DEPARTMENT OF ENERGY
National Nuclear Security Administration
Los Alamos Site Office
Los Alamos, New Mexico 87544

No. 2011-05
"Recommendation that Los Alamos National Laboratory Not Be
Selected for Disposal of Greater Than Class C Low-Level
Radioactive Waste"

Appendix I: Comment Response Document

Representative Values of Soil-Specific Exponential b Parameter

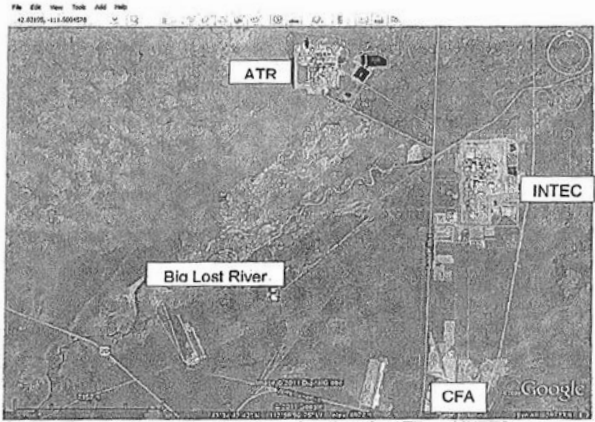
In this case a value ranging from 4.05 to 4.9 should be used instead of the RESRAD default value.

Figure 1: IEER's modeling results for trench disposal of GTCC and GTCC-like waste in a trench at Hanford

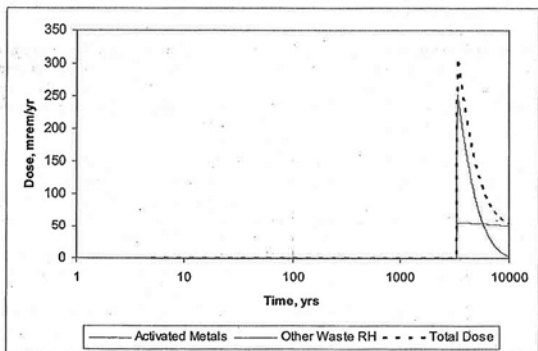
Figure 1 shows the results of IEER's verification calculations using the DOE assumptions so far as we could determine them from the Draft EIS (see Appendix A for more details).

As can be seen from Figure 1, IEER's peak dose estimate using the DOE's parameters so far as they could be determined is about 300 millirem per year. The activated metals dose is about 50 millirem and the Other Waste - RH dose is about 250 millirem. The total peak dose is about six times the DOE's estimate of 48 millirem noted above. Figure 2 below shows the results of DOE's trench disposal modeling in more detail.

Figure 2: The DOE's modeling results for trench disposal of GTCC and GTCC-like waste in a trench at Hanford
Source: Figure 6.2.4-1 in Draft GTCC EIS (Volume 1)

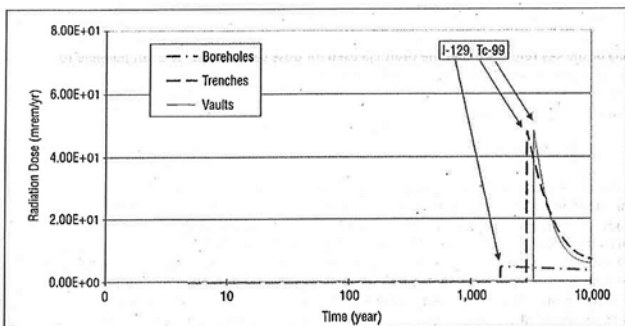
Further, it should be noted that the vast majority of the dose results from iodine-129 and technetium-99. The water pathway is the only one considered (both direct use and indirect doses via agriculture) and those doses are dominated by I-129 and Tc-99. This is a critical result that has considerable implications for the total body effective dose equivalent used by the DOE to the exclusion of organ dose estimation. This is discussed below when the sensitivity analysis is considered.

Figure 3: Total Dose for the Different Distances to the Well (Note: Base case distance to the well is 300 m, which is in between the case of very close (25 m) to the site boundary and 600 m).

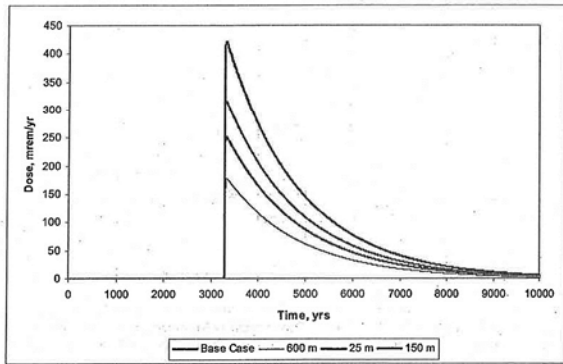
the site, so some comparison would be possible when other technical parameters were varied. The results of the sensitivity analysis regarding distance from the site boundary to the well are shown in Figure 3.

It is clear that the variation of a single parameter increases the dose from the most important component of the waste in terms of peak dose (Other Waste - RH) from about 250 mrem/year to over 400 mrem per year.

Figure 4: Base Case and Conservative Case for the Other Waste - RH category. (Note: The green line represents the total of activated metals and Other Waste - RH. The red line is Other Waste - RH alone)

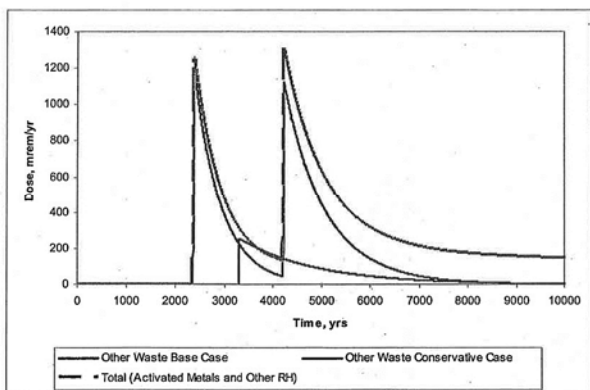
When all parameters are varied the upper limit of dose increases by about a factor of four for total dose and by more than a factor of four for the Other Waste - RH category. See Figure 4 below and Appendix A for more details.

Figure 5. Base Case and Cover Erosion and Aquatic Food Scenario for the Other Waste RH Category (red line). The green line shows dose for the total source term (other waste plus activated metals)

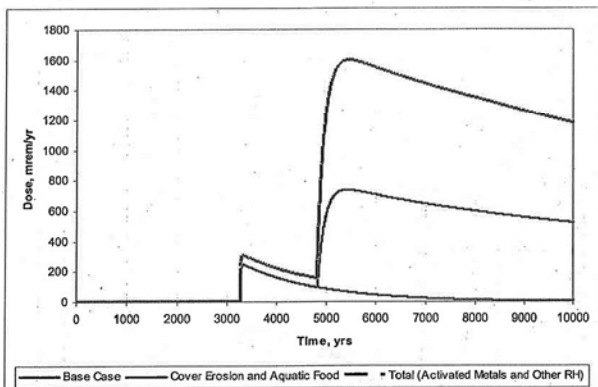
An erosion rate of 1 mm/year results in the 5-meter thick trench cover being completely eroded in 5,000 years. Hence, at that point, rain and snow contact the waste, some of which gets washed off into surface water. This means that the dose from the aquatic food pathway is significantly increased. Figure 5 shows the results for the cover erosion scenario. The red line shows the dose from Other Waste RH and the green line shows the total dose. Note that even though the other parameters, such as infiltration have been maintained the same as in the base case IEER model, there is a second peak dose, after the cover erodes, of about 1,600 mrem/year at somewhat over 5,000 years after disposal;

this is much greater than the first peak, which occurs due to groundwater use. The main reason for the higher second peak is the dose from consuming surface water and aquatic food from surface water sources.

Further, the major contributors to the second peak are the transuranic radionuclides Cm-245, Pu-239, and Pu-240. This is completely different from the Tc-99 and I-129 doses, which are important in the earlier peak.

Figure 6: Borehole Land Disposal Alternative for the Group 1 Stored Other Waste - RH Category

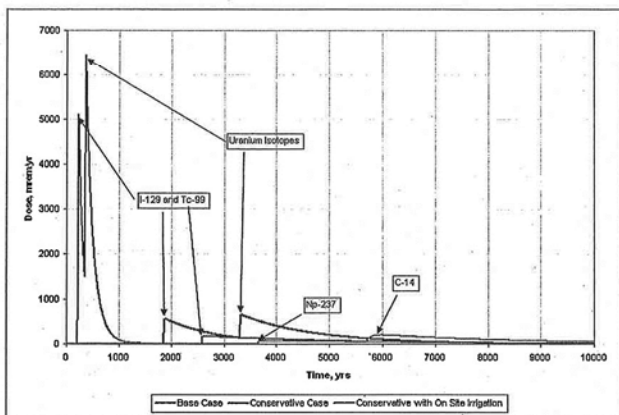
case of using irrigation from the site had two peaks – one of 5,050 mrem/year 235 years in the future due to I-129 and Tc-99 and one at 6,431 mrem/year 372 years into the future due to uranium isotopes. For context, the Draft EIS's estimate of peak dose due to borehole disposal was just 4.8 mrem/year – 37 times lower than the lowest borehole estimate when institutional controls are relaxed and more than 1,300 times lower when there is total loss of institutional control and memory.

Note that the highest dose in the irrigation scenario case is due to uranium – a strong reminder that large amounts of uranium are unsuitable for disposal even in boreholes as much as 40 m deep. So long as the disposal is relatively shallow and water is available beneath the disposal, the method is likely to be a problem from the point of view of a resident farmer and loss of institutional control.

Figure 1. Exposure Pathways Associated with the Use of Contaminated Groundwater

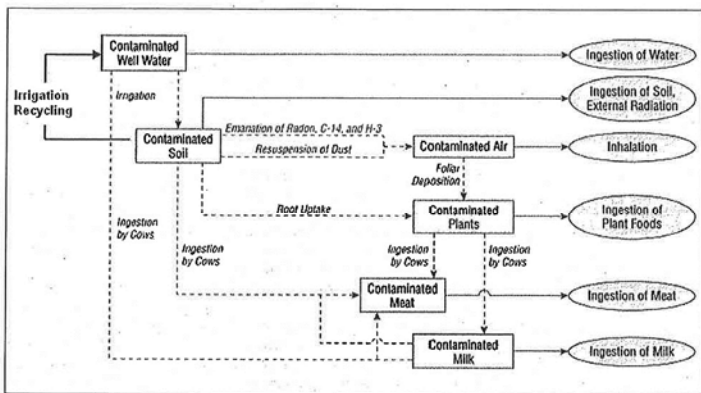
Note that this assumption is not adequate for this analysis because a significant portion of the offsite soils might be contaminated with the radionuclides deposited from contaminated irrigation water and from the surface runoff and dust originated from the contaminated site. Consequently, the infiltration water leaching through the contaminated offsite soils will be contaminated as well. RESRAD-OFFSITE only partially addresses this problem by considering the additional impacts from contaminated offsite soils. RESRAD-OFFSITE does not consider leaching of radionuclides from the contaminated offsite soils into the groundwater.

The exposure pathways associated with the use of contaminated groundwater implemented in RESRAD-OFFSITE are shown in Figure 1. The red arrow is added to the original figure presented in the draft EIS to demonstrate the missing link (irrigation recycling) between the contaminated offsite soil and the groundwater.

Figure 7. Base Case Independent Modeling Results for the 10,000 Year Simulation Period.

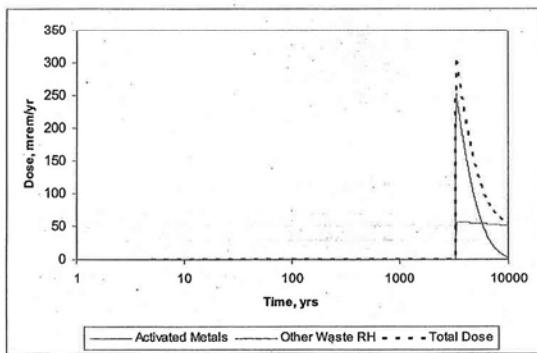
The results of the independent modeling are presented in Figures 7 and 8. The results from the draft EIS are reproduced in Figure 9 and 10.

NOTE: Base case leaching rates are 6.31×10^{-4} 1/yr for both I-129 and Tc-99.
 Figure 11. Total Dose for the Different Leaching Rates

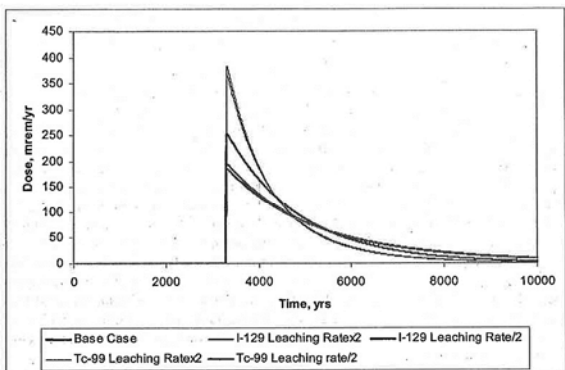
Figure 11 shows the impacts from using 2 times higher and 2 times lower leaching rate for I-129 and Tc-99. Because I-129 and Tc-99 are non-sorbing radionuclides (with retardation factor of 1), this is the same as to change infiltration rate at the top of the waste (Equation 1). A two-times higher infiltration rate represents 40% of the ambient infiltration case and two times lower infiltration rate represents 10% ambient infiltration case. The maximum dose related to I-129 increases 2 times when 2 times higher infiltration rate is used. Same is true for Tc-99. The increase in the total dose is smaller than 2 times because only one leaching rate was varied at the time (either I-129 or Tc-99).

NOTE: Base case distance to the well is 300 m.
 Figure 12. Total Dose for the Different Distances to the Well

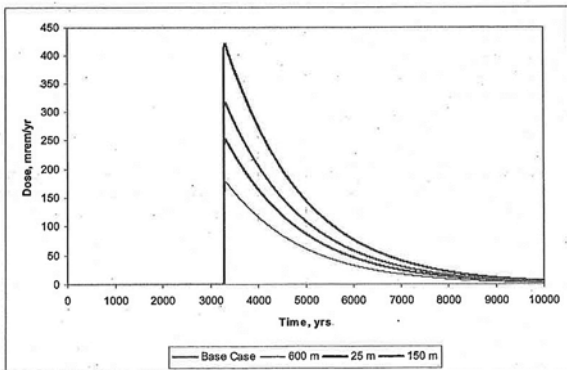
The impacts from the different distances to the groundwater well are shown in Figure 12. The dose increases 1.5 times due when the distance to the well is 2 times smaller and decreases 1.5 when it is 2 times greater.

NOTE: Base case ambient infiltration is 3.5 mm/yr, uranium K_d is 0.6 mL/g in 1st UZ layer and SZ
 Figure 13. Total Dose for the Different Ambient Infiltration Rates and Uranium Partition Coefficients

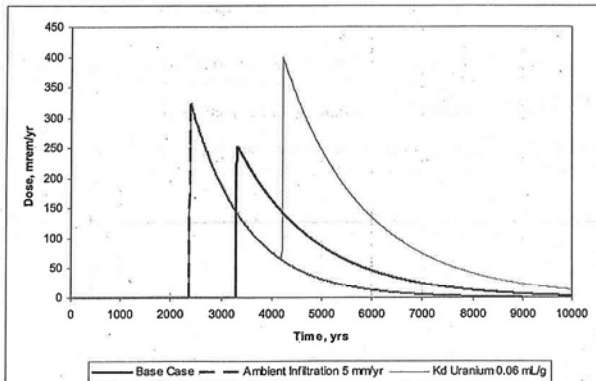
Figure 13 shows the impacts from the different ambient infiltration rates. When the ambient infiltration rate is 5 mm/yr, the peak dose is higher and it occurs about 1,000 years earlier. The peak dose is higher because the radionuclide release rates are higher (20% of 5 mm/yr instead of 20% of 3.5 mm/yr as in the base case). The peak occurs earlier because the travel time is faster under the higher infiltration conditions.

Note that the uranium isotopes do not reach the water table within the 10,000 year period in the base case. This is also true for the case with ambient infiltration of 5 mm/yr. Note that the uranium K_d s were set equal to 0.6 mL/g in the 1st layer of the unsaturated zone and in the saturated zone and to 0.06 mL/g in the 2nd layer of the unsaturated zone. The red line in Figure 13 shows the case with the ambient infiltration of 5 mm/yr in which uranium isotopes were assigned K_d of 0.06 mL/g in the unsaturated and saturated zone. In this situation uranium isotopes reach the groundwater table within 10,000 years and result in the second peak around 4,200 years.

NOTE: Base case consumption fraction is 0.5.
Figure 14. Total Dose for the Different Consumption Fractions

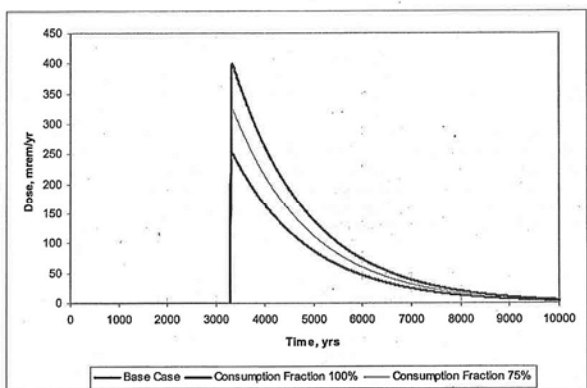
Figure 14 shows the impacts due to the different consumption fractions. When 100% of food comes from contaminated areas (2 times more than in the base case), the total dose increases 1.6 times.

NOTE: Base case irrigation rate is 0.2 m/yr
Figure 15. Total Dose for the Different Irrigation Rates of Fruits, Grains and Non-Leafy Vegetables.

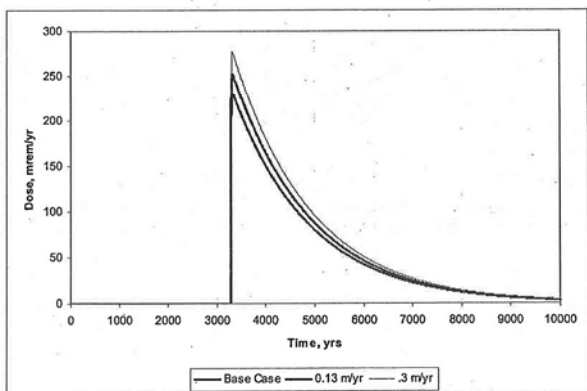
Figure 15 shows the impacts from the irrigation rate of the fruit, grain, and non-leafy vegetables. The impacts are smaller than in the previous cases, but still noticeable.

Figure 16. Base Case and Conservative Case for the Other Waste RH Category

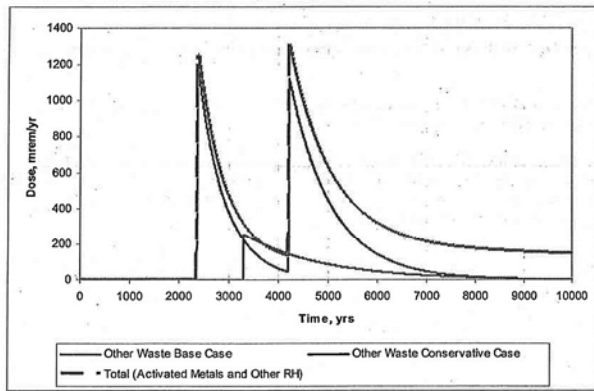
Figure 16 compares the base case to the conservative case for the other waste RH category. Figure 17 compares the base case to the conservative case for the activated metals category. The total dose (activated metal and other waste RH) is plotted in both figures as well. In both cases, the peak doses in conservative case are more than 4 times higher.

Figure 18. Major Pathway Contributions for the Base Case

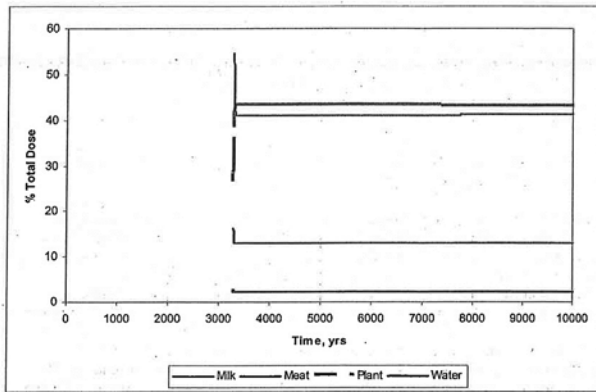
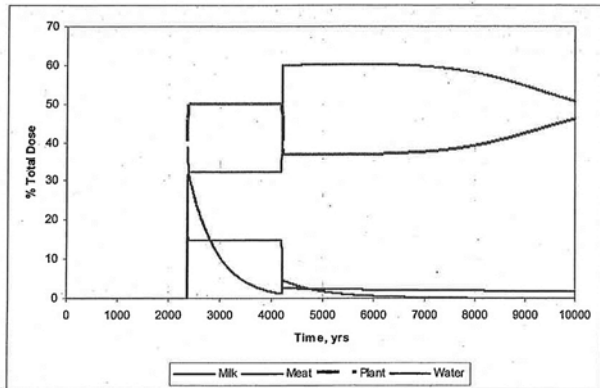
The contributions of the major exposure pathways for the base case and the conservative case for the other waste RH category are shown in Figures 18 and 19.

In both cases, the major contributors are drinking water ingestion and plant food (contaminated with irrigated water) pathways. Ingestion of milk and meat plays less significant role. The significance of drinking water and plant food changes with time as shown in Figure 19 when uranium isotopes reach the groundwater well around the simulation year 4,200.

Figure 20. Base Case and Cover Erosion and Aquatic Food Scenario for the Other Waste Category (red line). The green line shows dose for the total source term (other waste plus activated metals)

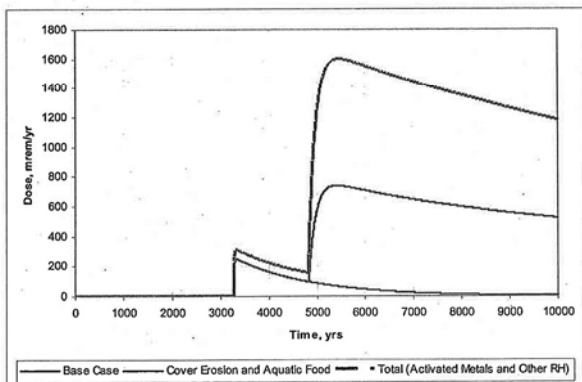
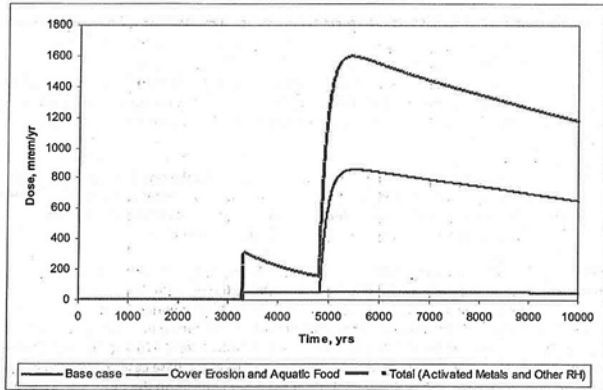
As can be seen from these figures, the cover erosion and aquatic food scenario significantly affects the total dose. In both cases, there is a second dose peak, which is 6.5 times higher than the 1st peak. The differences begin to surface when the cover starts to disappear (around year 5,000). At this moment the waste becomes exposed at the surface and is a subject of the surface water transport. The major contributors to the second peak are Cm-245, Pu-239, and Pu-240. The major pathway is the aquatic pathway.

Figure 22. Borehole Land Disposal Alternative for the Group 1 GTCC-Like Stored Other Waste - RH Category

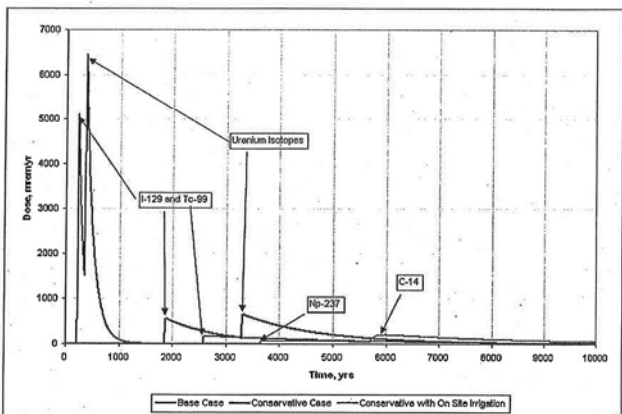
The results of these simulations are shown in Figure 22. The peak dose in the base case is 177 mrem/yr at 2,650 years and it is related to I-129 and Tc-99. The other radionuclides do not reach the ground water well in 10,000 years.

Note that the infiltration rate and radionuclide specific partition coefficient have the greatest impacts on the total dose. The distance to the well is of less importance because the radionuclide transport in the saturated zone is significantly faster than in the unsaturated zone.
